ALTICO SERVICE BULLETIN **#ASB 060700**

DATE: **JUNE 7, 2000**

SUBJECT: STIFFENER IN TOP FLAP OF DOLPHIN MAIN CONTAINER

INSPECTION AND REPAIR/UPDATE OF DOLPHIN MAIN TOP FLAP IN COMPLIANCE WITH SERVICE BULLETIN #ASB 060700

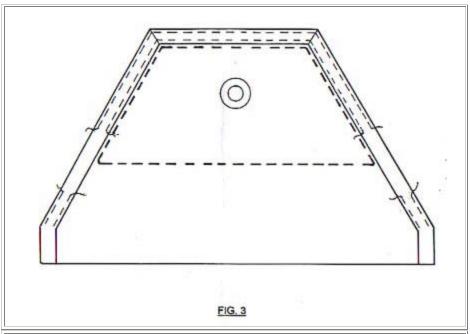
1) Inspect underside of main top flap at points indicated in <u>FIG. 1</u>. If a corner of the plastic stiffener is exposed by wear, proceed to step 2.

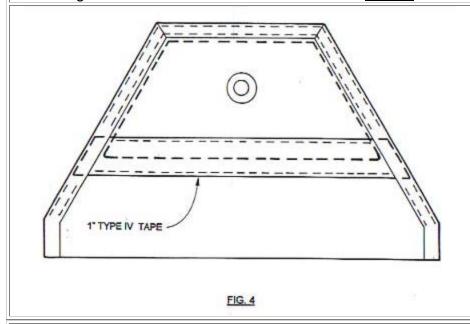
3) Remove the stitches from a 1-3/4" (approx.) section of binding tape along each side of the main top flap. The section of removed stitches must be centered on the edge of the stiffener as shown in FIG. 3. This is done so that the ends of the reinforcing tape may be installed under the binding tape.

4) Center the prepared piece of 1" Type IV tape over the edge of the stiffener and stitch as shown in FIG. 4.

5) Replace the stitching in the binding, covering the ends of the Type IV reinforcing tape and oversewing approx. 1" on each side.
